VEHICLE RECALL

AMERICAN TRANSPORTATION RECALL # 01305
NHTSA RECALL # 01V-350

SUBJECT: VEHICLE RECALL
Heater/Defroster Harness Connection Wiring

FUSE PANEL BELOW DRIVER'S WINDOW Circuits # 7 & 8

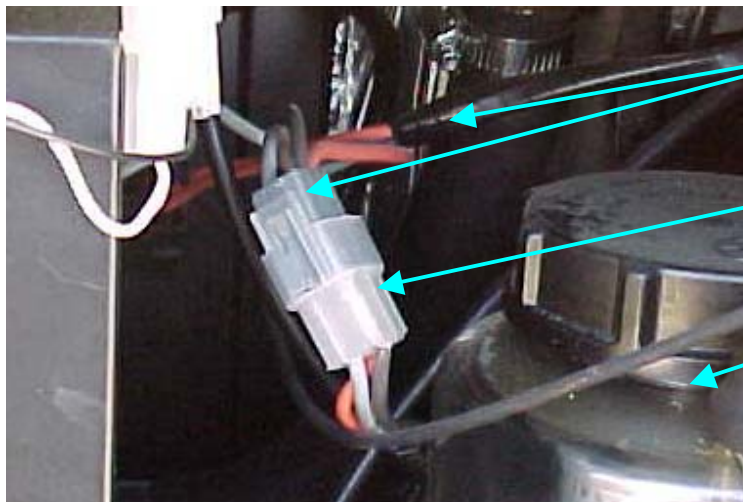
WARNING: Remove the circuit protection for circuit's number 7 and 8 on the fuse panel located just under the driver's window on the outside of the unit. This protects against accidental shorting while making the repair.

Picture showing harness connection properly wired.

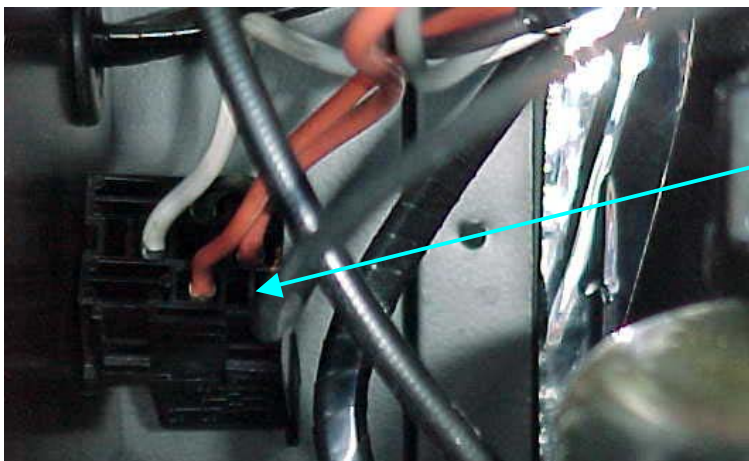
To access the connector wiring, open the right front panel (entrance door side of unit) that has the wiper motor system mounted. Inside this compartment you will find the connector for the heater harness. The heater switch harness with the gray connector has a white, brown, gray and orange wire. Also you will find a relay with a connector mounted to the heater box.

Picture shows the correct wiring at the relay connector.

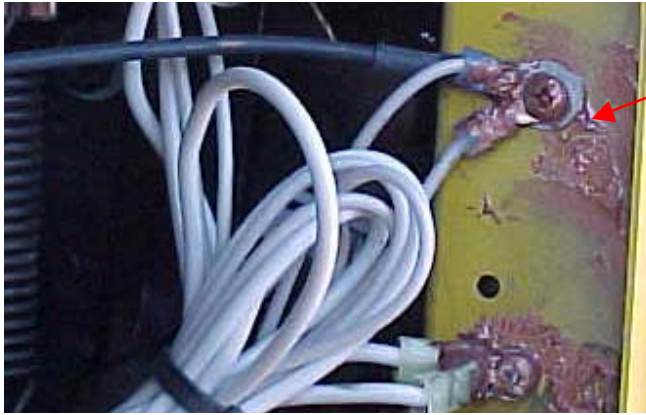
1. Remove the relay connector from the relay located on the heater housing behind this connector.

Ground screws right side of door opening.

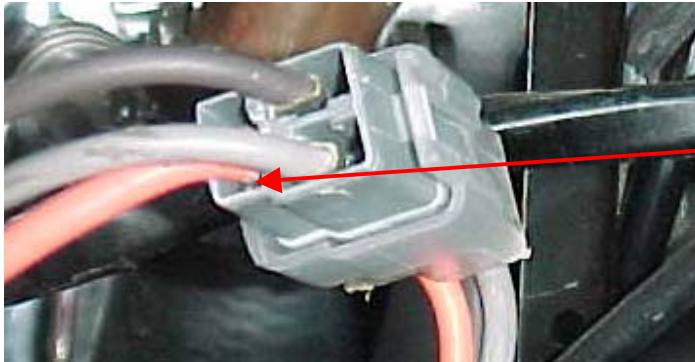
2. Connect the ring lug on the ground wire from the relay connector (the black wire in slot 85) to either ground stud on the bus.

Relay Connector

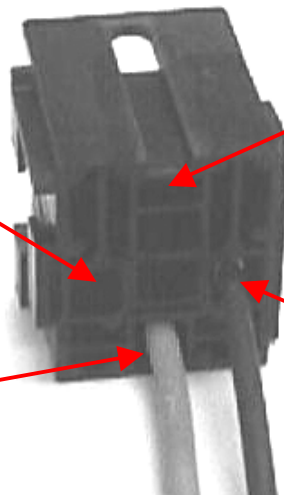
3. Unplug the switch harness connector (gray connector) from the heater harness connector (white connector).
4. Remove the orange wire from the switch harness connector. Plug it into slot 86 on the relay connector. See detailed relay picture below.
5. Plug the white wire (the hot wire from the power supply in the switch harness) into slot 87 on the relay connector. See detailed relay picture below.
6. Plug the orange wire (high output) from the relay connector (location 30) into the top location of the gray switch connector on the heater switch harness.

Slot 86 Insert high orange output wire from heater switch harness that was in the gray switch harness connector.

Slot 30 High orange output wire. This wire will plug into the gray switch harness connector.

Slot 87 Insert white (hot) power supply wire from the heater switch harness.

Slot 85 Black ground wire. Connect to ground stud on the bus.

Picture shows correct assembly of wires when repaired.

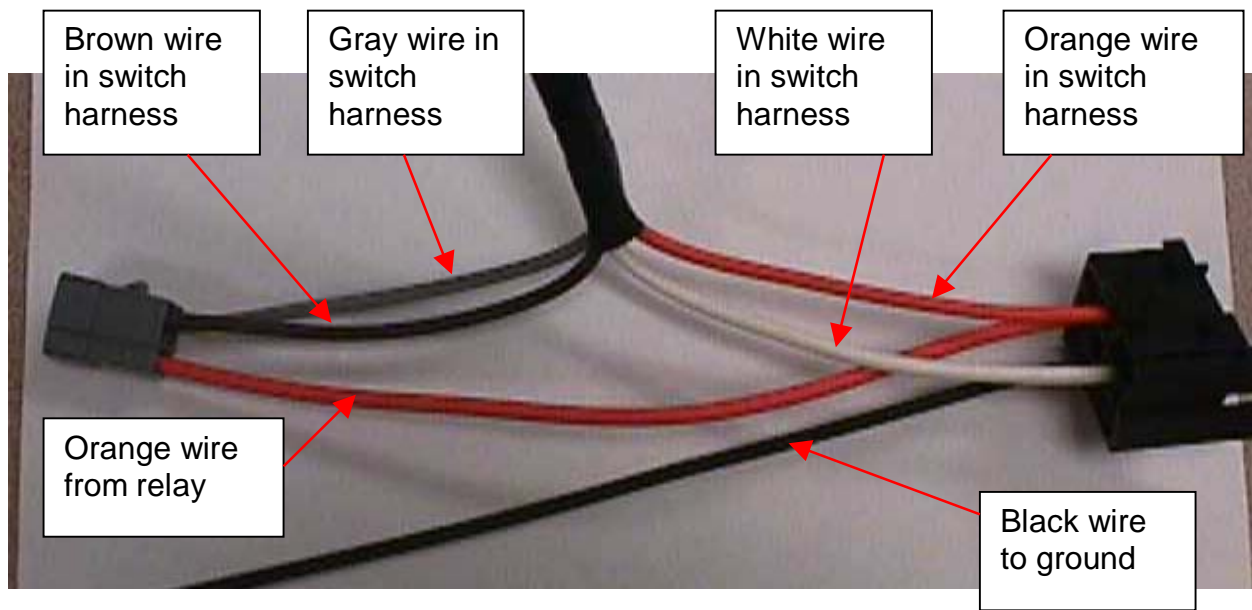
7. Finally, connect the two harness connectors and plug the relay connector into the relay.
8. Replace circuit protection that was removed and check to make sure that the blower fan operates on all three speeds.
